5/039/010

NOTICE OF INTENTION TO REVISE MINING
ML 47244 MN-04-01-06(1)

10/05/2004

W147244

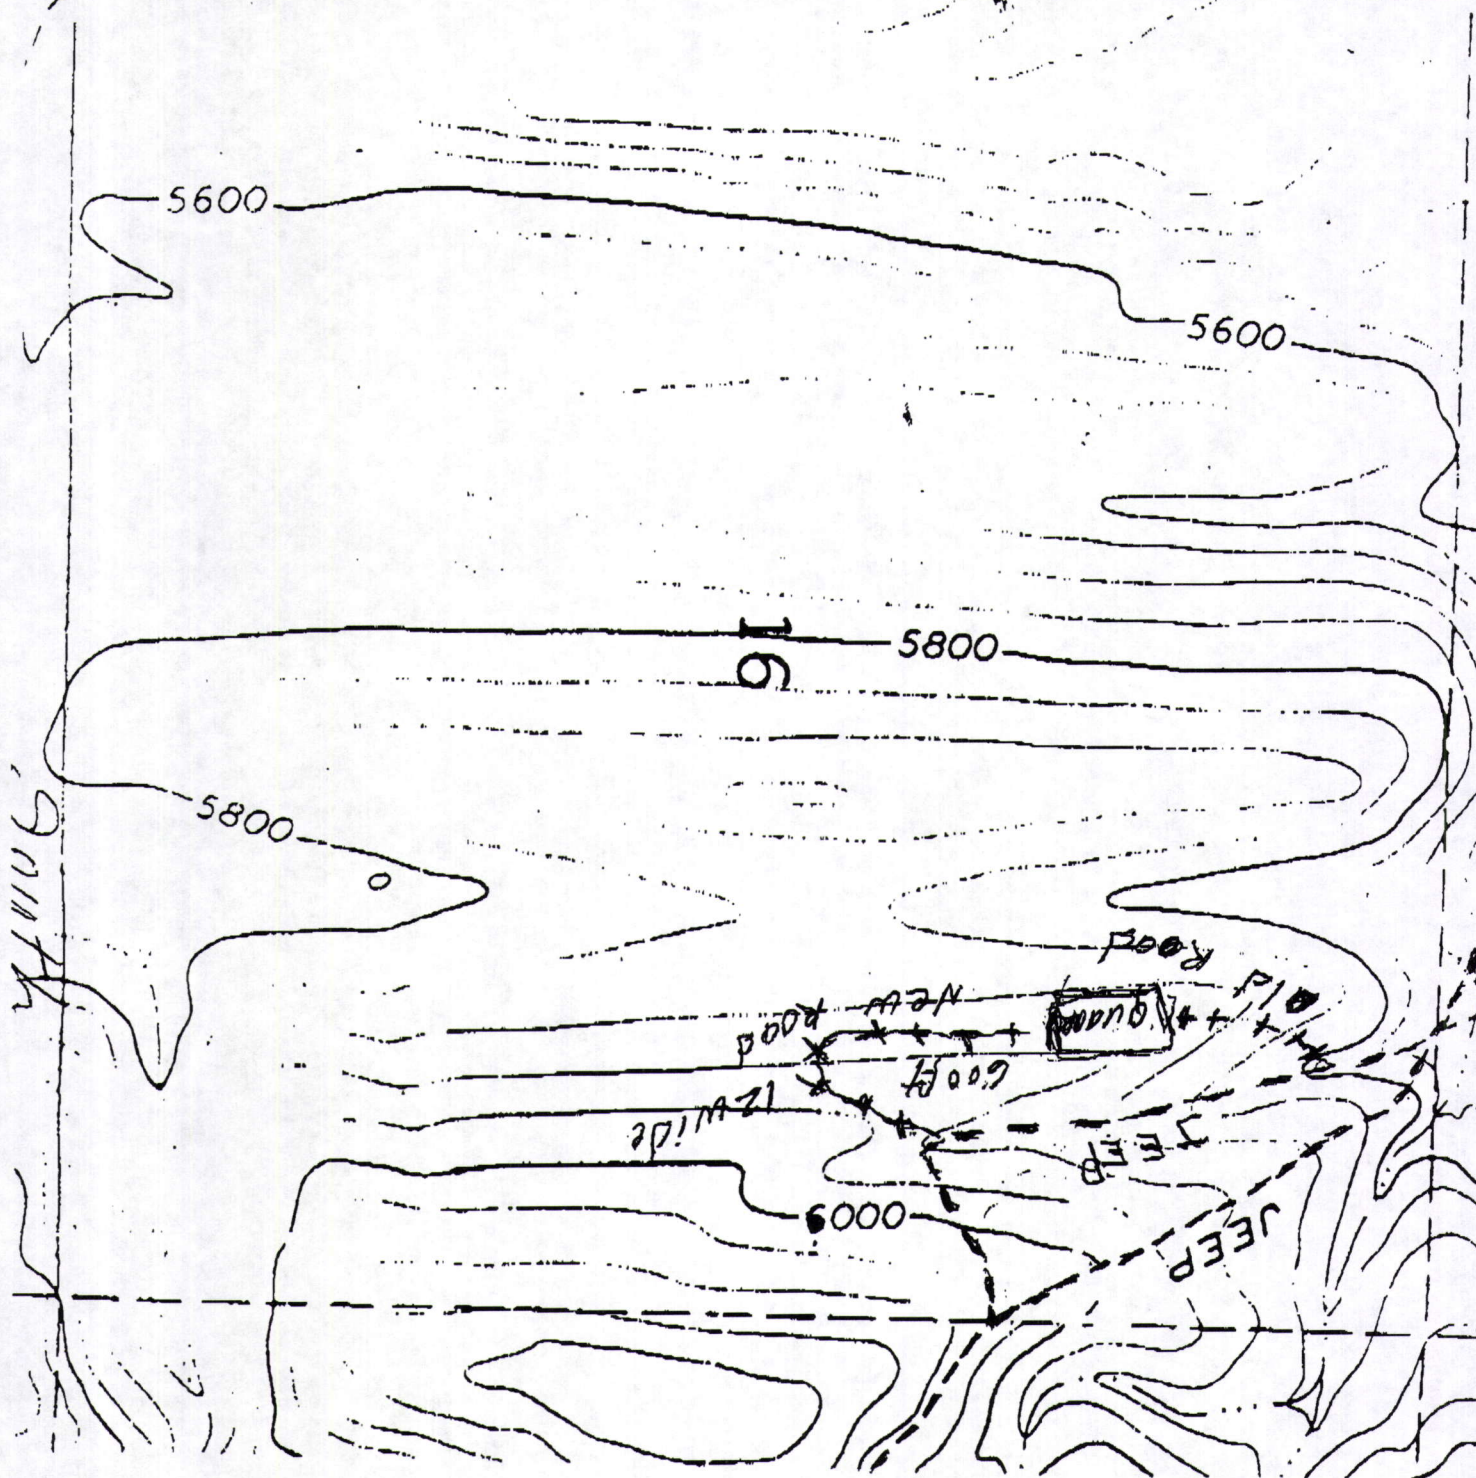
Intention is to change existing road to South East part of quarry. Reason for this is the existing road is too steep to use in bad weather. There is a safety issue bringing truck loads of stone down a road with that much of an incline such as the existing road has.

New road consists of 600 feet long by 12 feet wide. Map will be sent showing location of old road and that road will be reclaimed when we receive permission to use the new road. Map will show location of the new road. Please notify us if we need to supply more information.
